BRANDT ADDITION

Final Plat

LANCASTER COUNTY ENGINEERING DEPARTMENT
444 Cherrycreek Road, Building C
Lincoln, NE 68528
(402)441-7681
**DRIVEWAY APPLICATION
ONE ACCESS ONLY**

DRIVEWAY ACCESS PERMIT
LANCASTER COUNTY ENGINEERING DEPARTMENT
 444 Cherrycreek Road, Building C
 Lincoln NE, 68528-1578
 (402)441-7681

PERMIT # **7853**

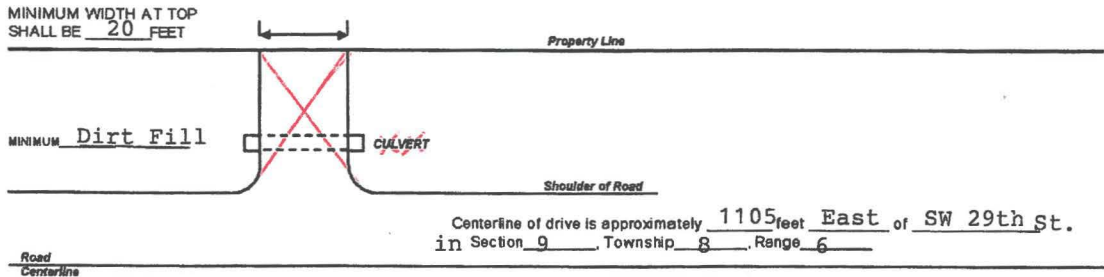
COMMENTS: Residential access for Lot 2, Brandt Addition is at the existing access drive on the 20' wide common access easement located 245' +/- east of the SW corner of Lot 1, Brandt Addition per final plat dedication note recorded on Inst. #2012025976 at the Register of Deeds Office. (see attached plat).

Existing Drivl
Permit # 7853

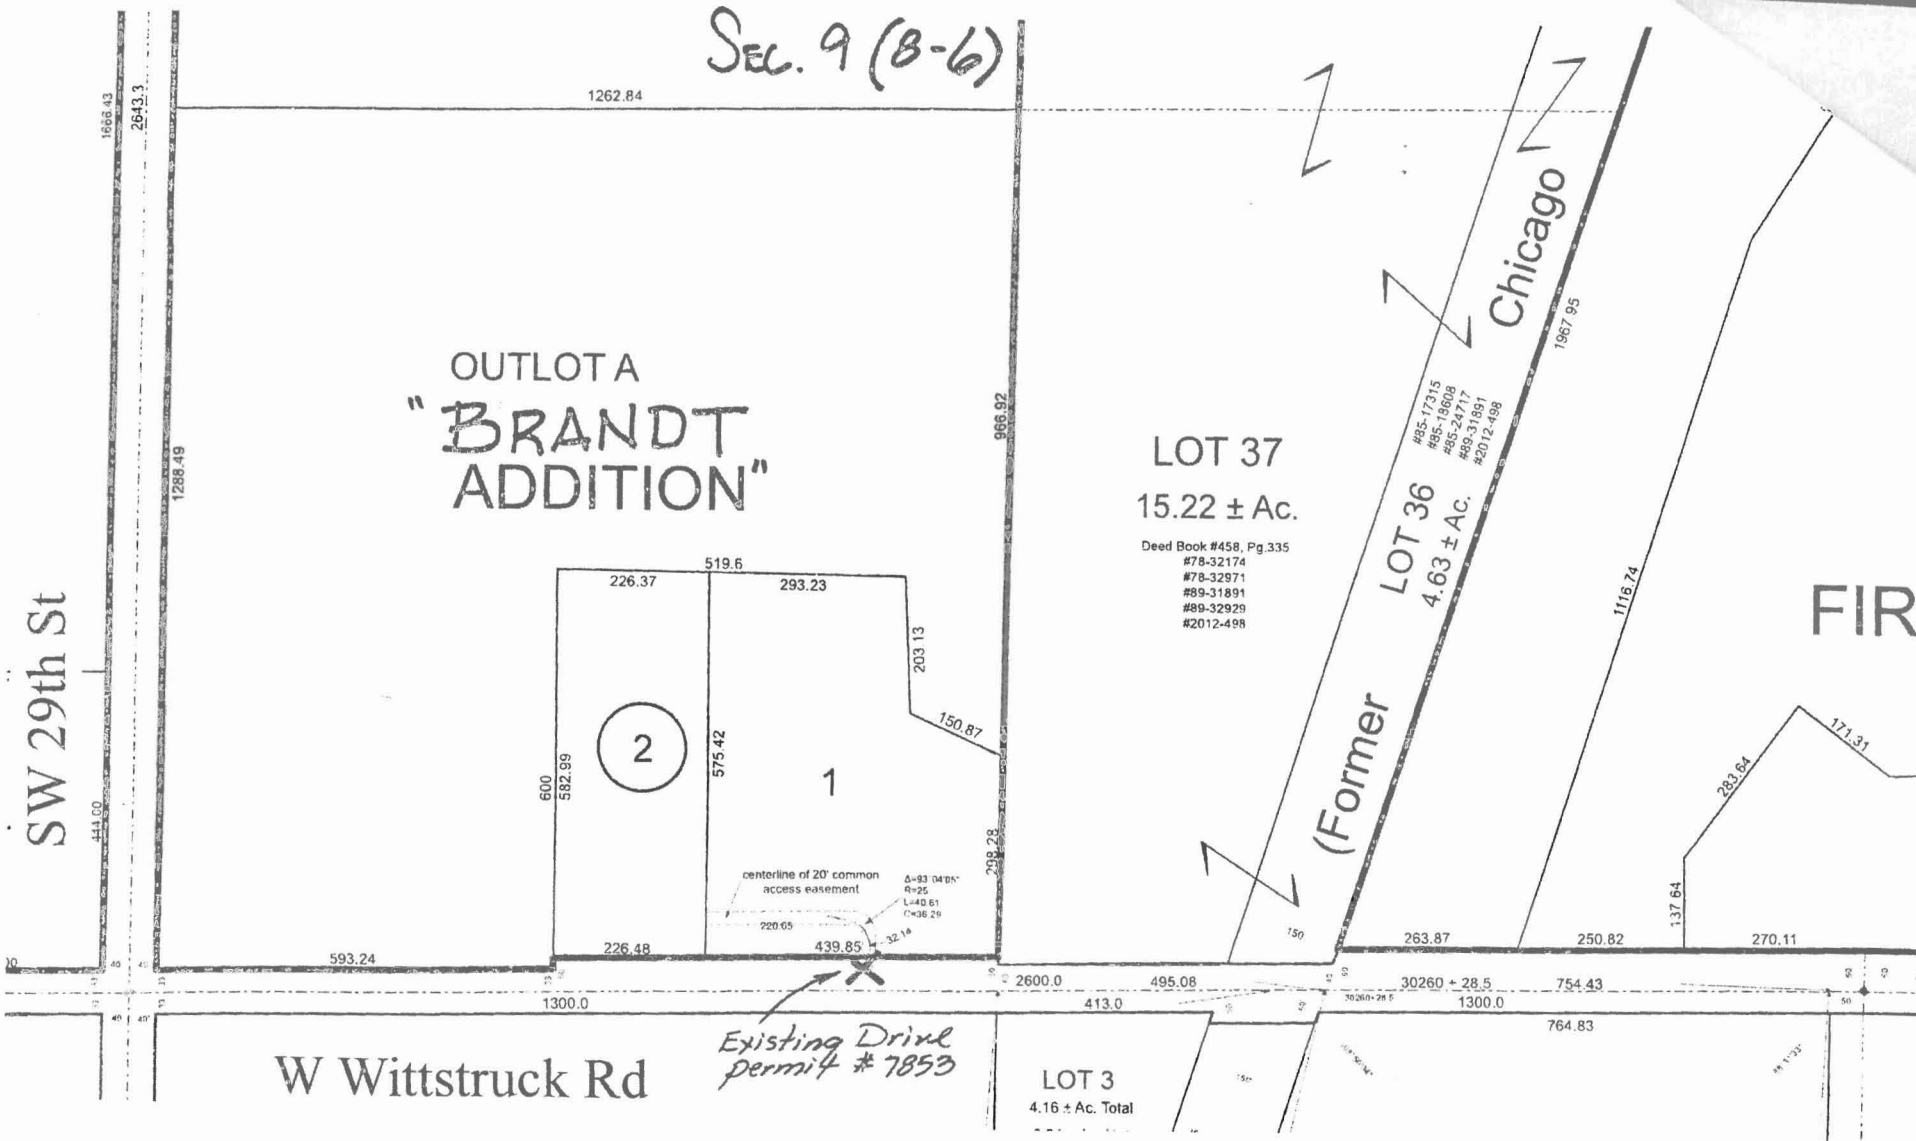
This residential access permit is denied given that Lot Two (2), Brandt Addition, already has a residential address assigned in a previous access permit, #7853, dated 03/07/2016 (See Attached). The existing drive mentioned in permit #7953 is the Field Drive that is allowed to Outlot "A" of Brandt Addition, approved per Permit #7877, and is not allowed to be used for residential access to Lot Two (2), Brandt Addition. Access to Lot Two (2), Brandt Addition, is from an existing twenty-foot (20') wide common access easement located 245' +/- east from the Southwest Corner (SWC) of Lot One (1), Brandt Addition, per final plat dedication note recorded as Instrument 2012025976, Lancaster County Register of Deeds Office (See Attached).

This permit is hereby Denied for installation, subject to the general rules and regulations governing this work and subject to such regulations as the County may deem necessary with final acceptance pending Post Construction field inspection approval below.
